FOR PERCOLATION TESTING AND SITE EVALUATION

SITE INSPECTION SHEET

RE: **Building Permit # B15002110**
3316 Hipsley Mill Road
Woodbine, Maryland 21797

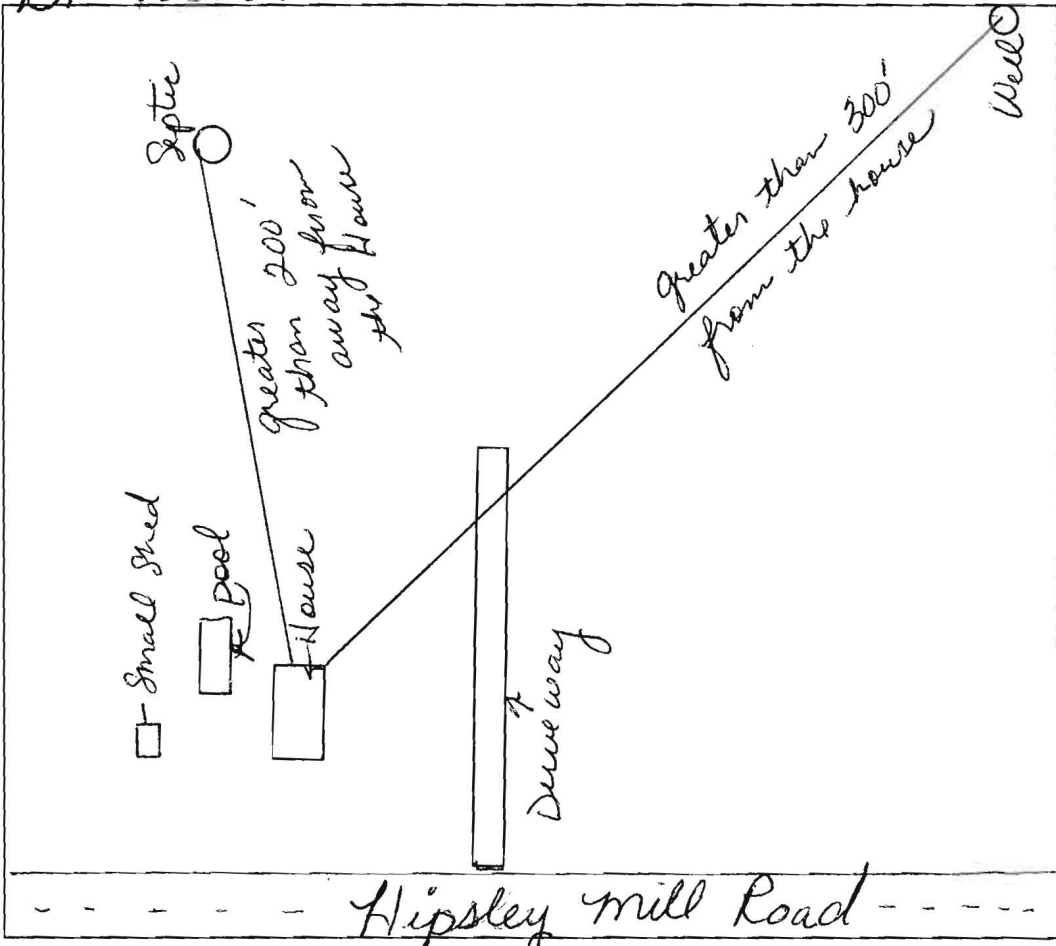
Dry well fail g; has 'Repair Trench' 'Repair Trench' sils; black-coated gravel pot full depth and full of solution.
